**RECORD DRAWINGS** August 2011

<b>STONE CREEK RETAIL</b>		STATUS		DATE	BY
STREET ADDRESS		DATE DRAWN		FEB 2011	CC
SH 205 & SH 552		PLAN CHECKED			
CITY	STATE	AS-BUILT			
ROCKWALL	TEXAS				
COUNTY:	SURVEY:	ABSTRACT NO.			
ROCKWALL COUNTY	W.T. DEWEESE	---			
L/C NUMBER:	CORPORATE DWG. NAME				
042-2854	EROSION CONTROL DETAILS		C3.1

**STABILIZED CONSTRUCTION ENTRANCE**

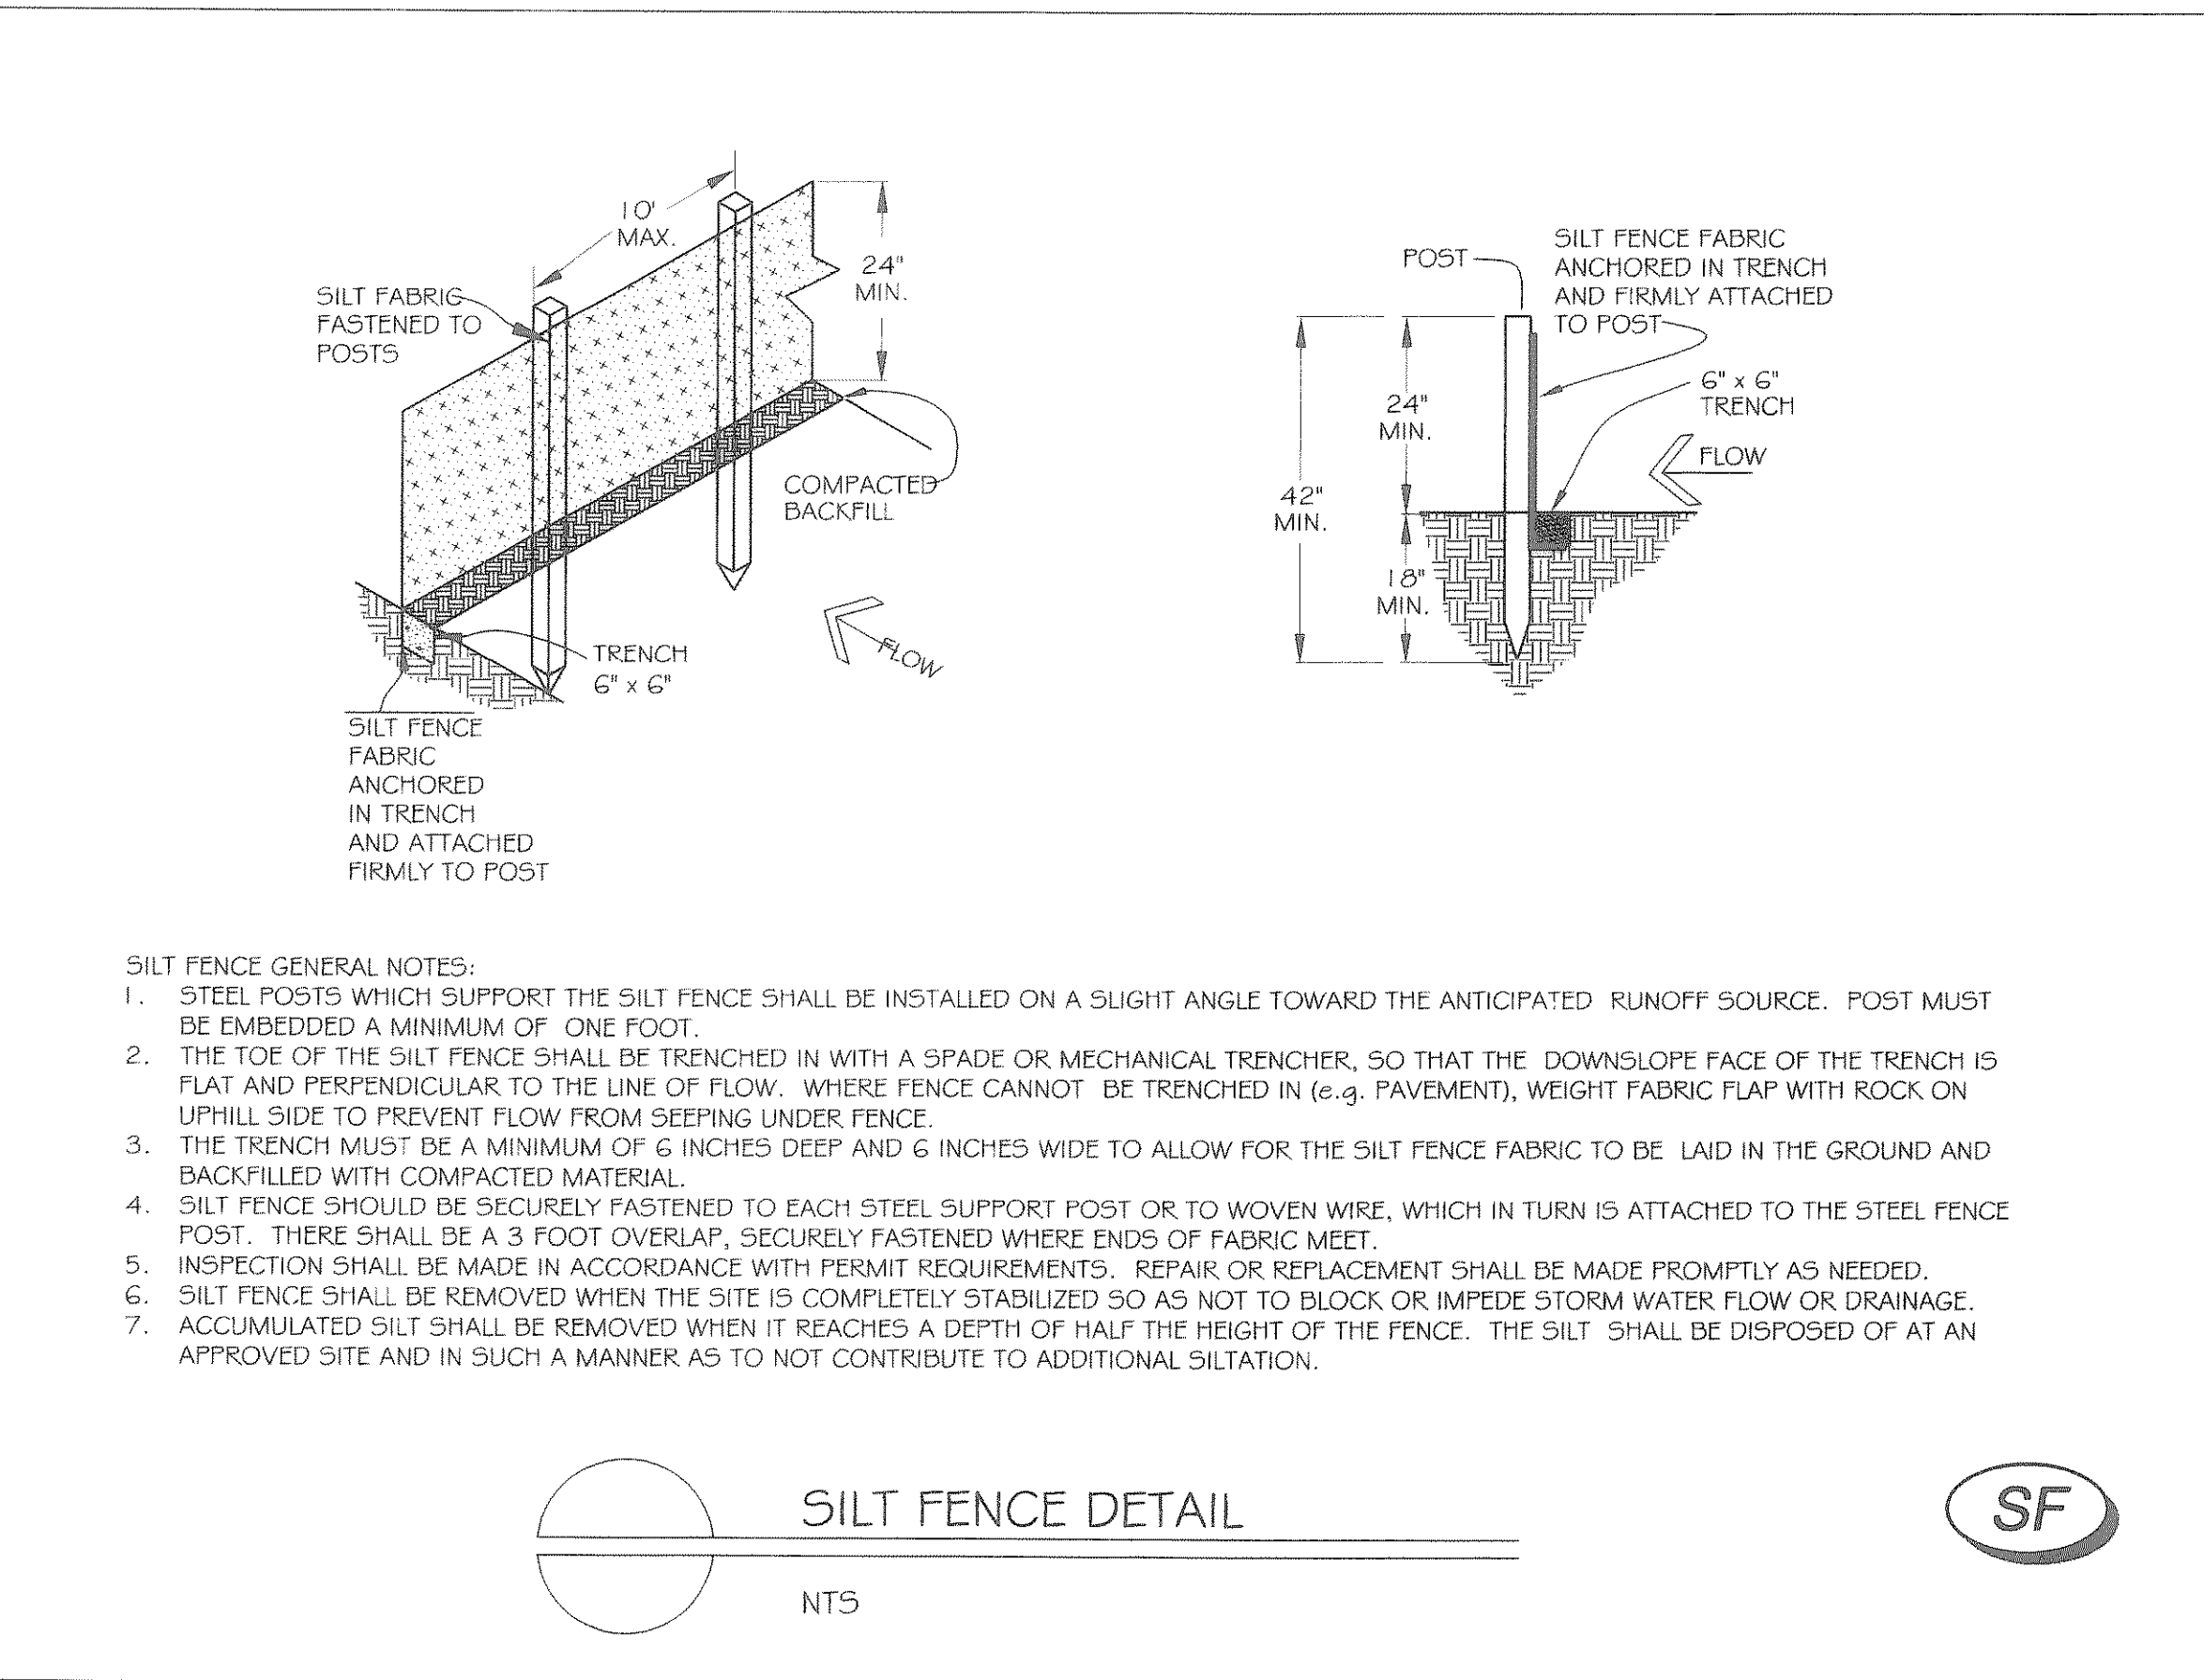
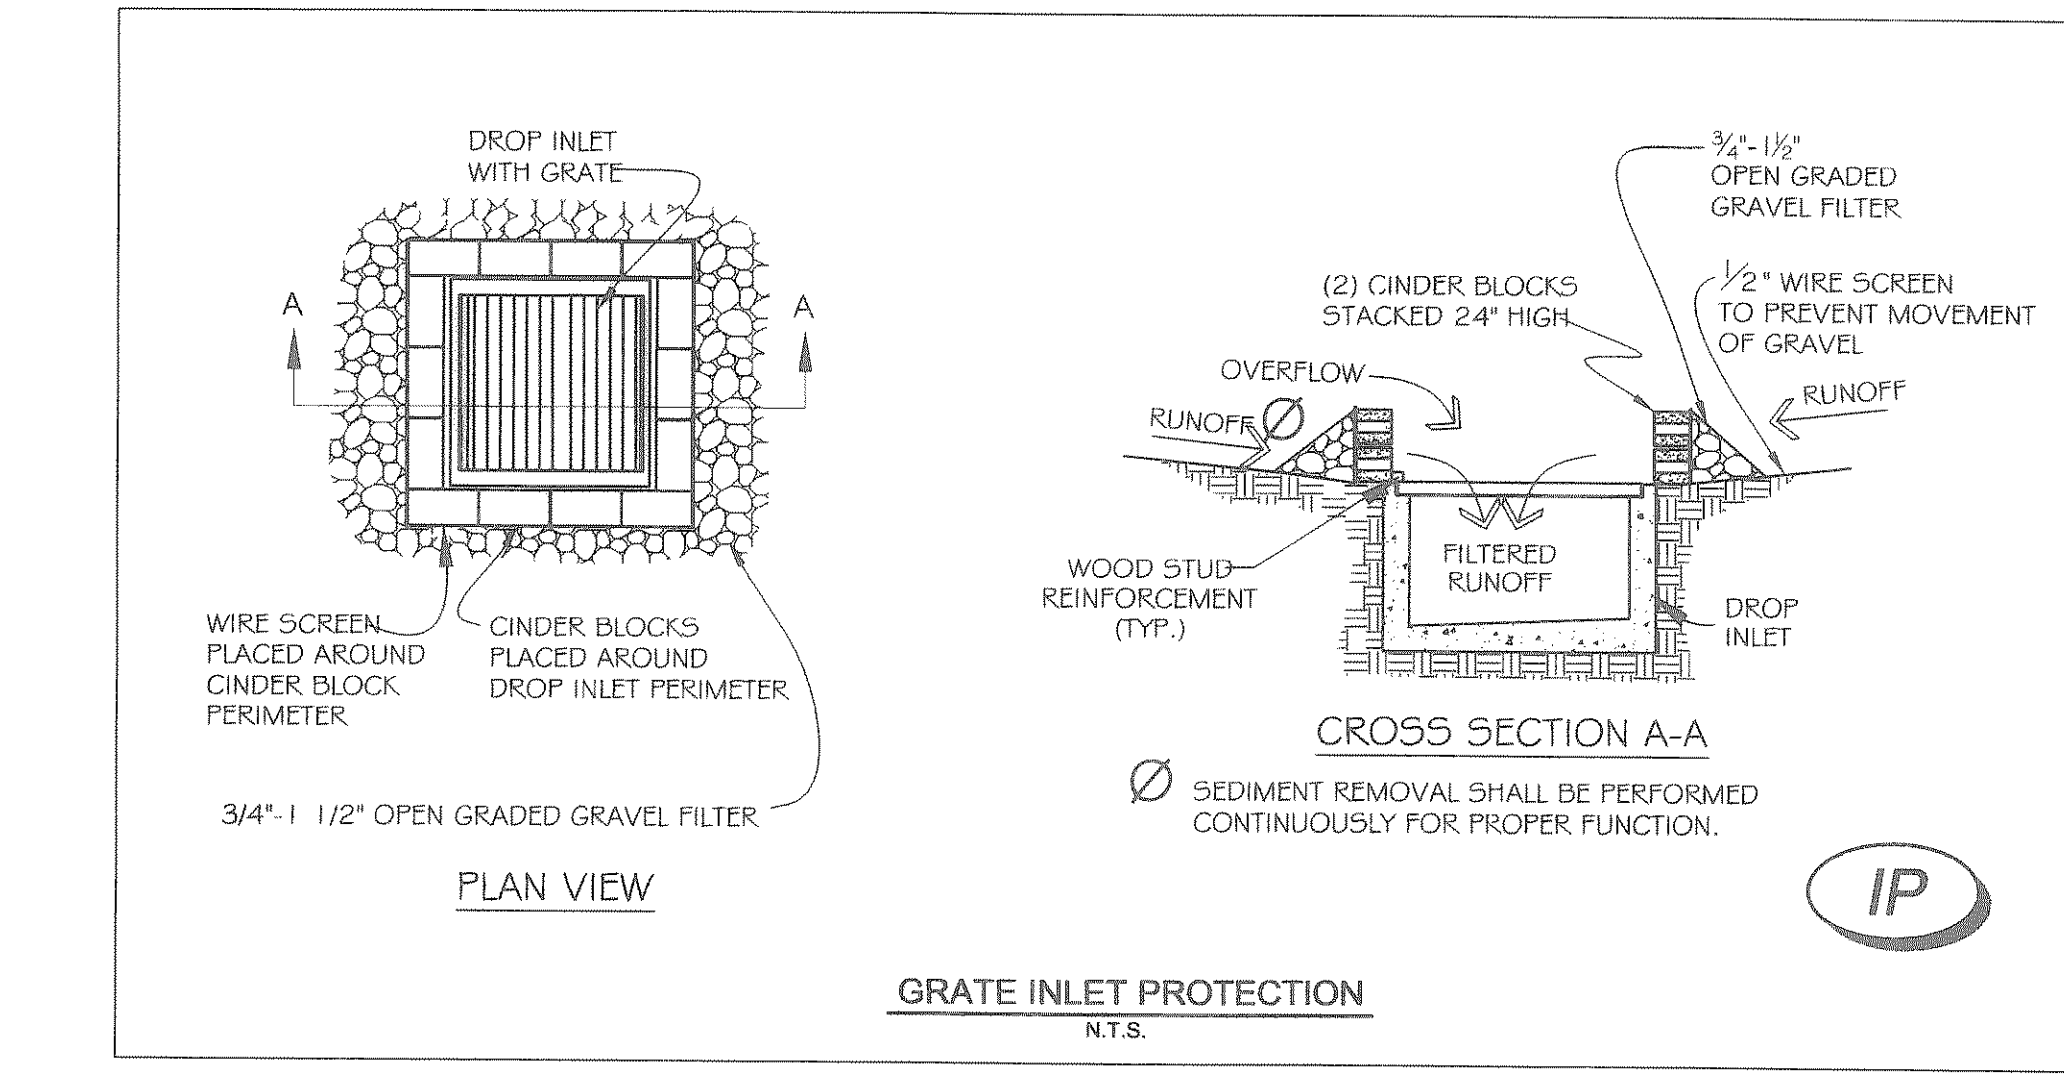
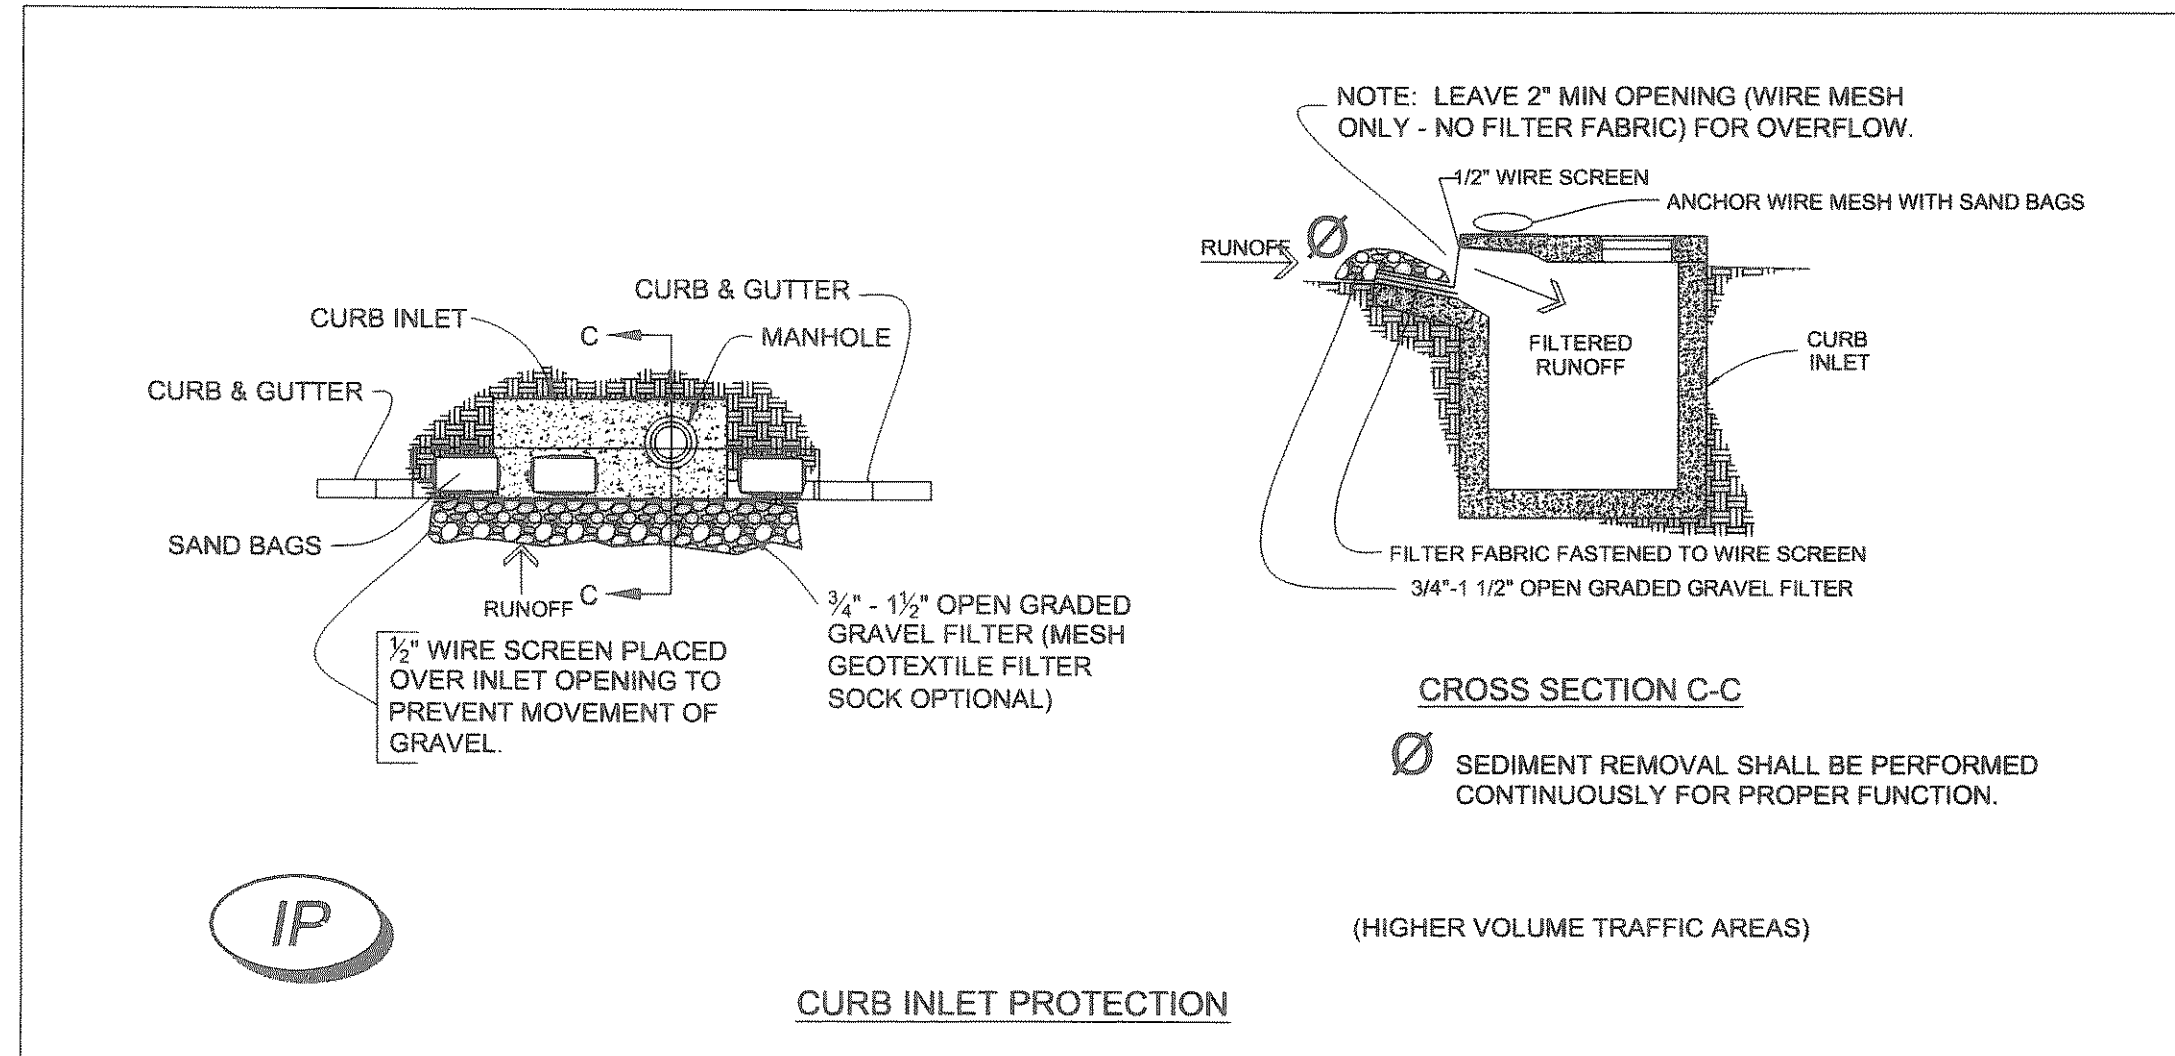
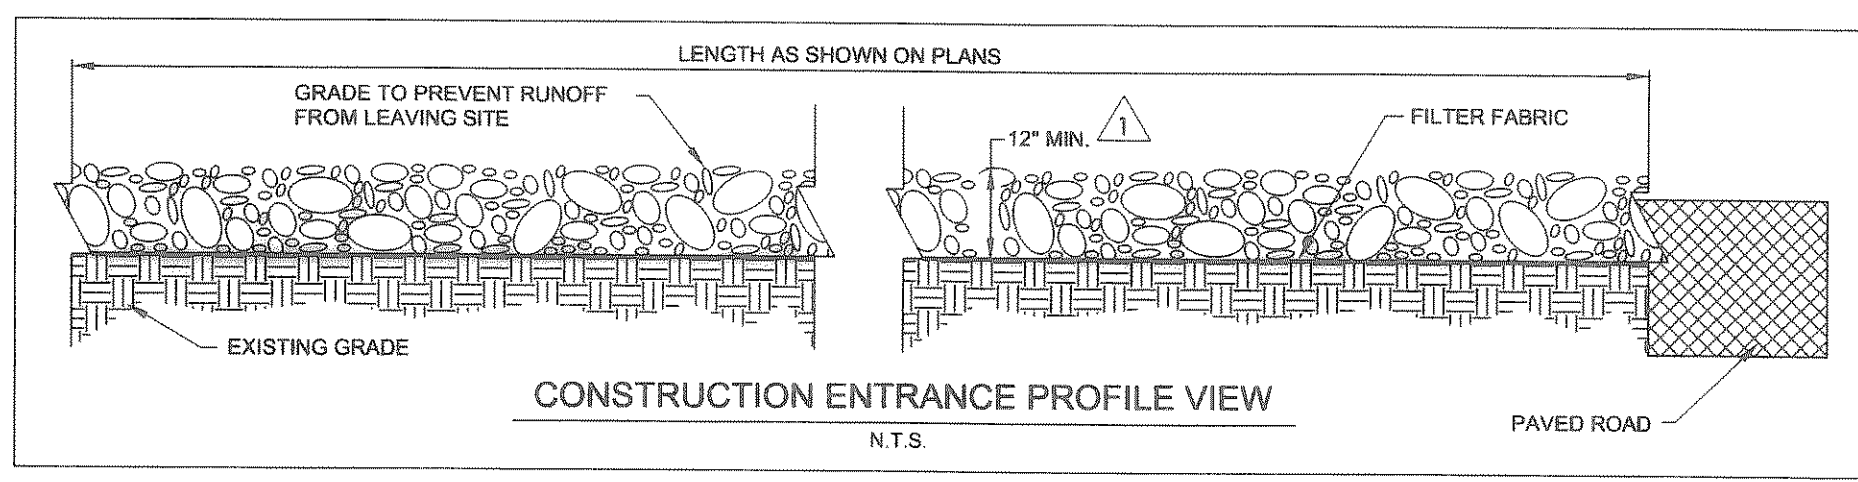
**REV'S PER CITY 03/03/2011**

- CHANGED CRUSHED DEPTH FROM 8" TO 12" ON CONSTRUCTION ENTRANCE PROFILE.
- EDITED CONSTRUCTION ENTRANCE NOTES PER CITY COMMENT.
